# Access Compliance Report

## Public Rights-of-Way

### (Curb Ramps)

Intersection ID: 31717	Main Street: MOSSYCUP_DR	Cross Street: PLOWDON_CT	Location: SW
ADA ID: 37E9895A2FFC	Ramp Type: PerpDiag	Initial Pass/Fail: Fail	Overall Compliance: No
Severity Score: 37.5			
Codes/Mitigation Info/Possible Solution		Field Measurements/Component Compliance

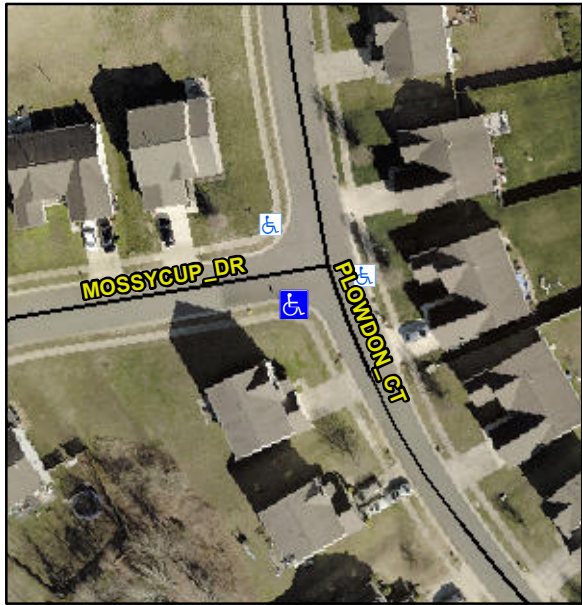
Possible Solutions:							
	<b>Remove &amp; Replace Curb Ramp With Two New Directional Ramps or Equivalent.</b>							
	Surveyor Notes:							
	<b>N/A</b>							
	PROW/ADA:							
	<b>Not Found, R304.2.2, R304.5.3</b>							
	Street 1 Name	<b>PLOWDON CT</b>	Compliance	Description	Data	Compliance	Description	Data
	Stop Condition-Street 2	<b>None</b>	<b>N/A</b>	Ramp Length (in)	<b>47.0</b>	<b>No</b>	Ramp Slope (%)	<b>10.6</b>
	Street 2 Name	<b>MOSSYCUP DR</b>	<b>Yes</b>	Ramp Width (in)	<b>48.0</b>	<b>No</b>	Ramp XSlope (%)	<b>8.1</b>
	Stop Condition-Street 1	<b>StopSign</b>	<b>N/A</b>	Flare Type LT	<b>N/A</b>	<b>N/A</b>	Flare Type RT	<b>N/A</b>
		<b>N/A</b>	Flare Slope LT (%)	<b>N/A</b>	<b>N/A</b>	Flare Slope RT (%)	<b>N/A</b>	
		<b>N/A</b>	Flare Traversable LT?	<b>N/A</b>	<b>N/A</b>	Flare Traversable RT?	<b>N/A</b>	
		<b>N/A</b>	Landing Length (in)	<b>N/A</b>	<b>N/A</b>	DWS Provided?	<b>N/A</b>	
		<b>N/A</b>	Landing Width (in)	<b>N/A</b>	<b>N/A</b>	DWS Contrast?	<b>N/A</b>

<b>N/A</b>	Landing Slope (%)	<b>N/A</b>	<b>N/A</b>	DWS Length (in)	<b>N/A</b>	
		<b>N/A</b>	Landing X Slope (%)	<b>N/A</b>	<b>N/A</b>	DWS Full Width?	<b>N/A</b>	
		<b>N/A</b>	Landing Curb? (Y/N)	<b>N/A</b>	<b>N/A</b>	DWS Offset (in)	<b>N/A</b>	
		<b>N/A</b>	Shared Landing?	<b>N/A</b>				
		<b>N/A</b>	Gutter Ponding?	<b>N/A</b>	<b>N/A</b>	Gutter Slope (%)	<b>N/A</b>	
		<b>N/A</b>	Gutter Lip Ht (in)	<b>N/A</b>	<b>N/A</b>	Gutter X Slope (%)	<b>N/A</b>	
		<b>N/A</b>	Painted X Walk1?	<b>No</b>	<b>N/A</b>	Painted X Walk2?	<b>No</b>	
			X Walk 1 Direction	<b>To E</b>		X Walk 2 Direction	<b>To N</b>	
		<b>N/A</b>	X Walk 1 Width (in)	<b>N/A</b>	<b>N/A</b>	X Walk 2 Width (in)	<b>N/A</b>	
			X Walk 1 Slope (%)	<b>5.3</b>		X Walk 2 Slope (%)	<b>0.1</b>	
			X Walk 1 X Slope (%)	<b>5.9</b>		X Walk 2 X Slope (%)	<b>6.8</b>	
		<b>N/A</b>	Ramp inside XWalk1?	<b>N/A</b>	<b>N/A</b>	Ramp inside XWalk2?	<b>N/A</b>	
			Road Slope (%)	<b>7.7</b>	<b>N/A</b>	Clear Space?	<b>N/A</b>

Road X Slope (%)	<b>1.2</b>	<b>N/A</b>	Clear Space to XWalk (in)	<b>N/A</b>	
		<b>N/A</b>	Any Obstructions?	<b>N/A</b>	<b>N/A</b>	Storm Grate/Utility Hazard?	<b>N/A</b>	
			Obstruction Type			Storm Grate/Utility Type		
				<b>N/A</b>			<b>N/A</b>	
					<b>Yes</b>	Surface Condition? (G/P)	<b>Good</b>	
Total Cost:		<b>\$</b>	<b>3200.00</b>
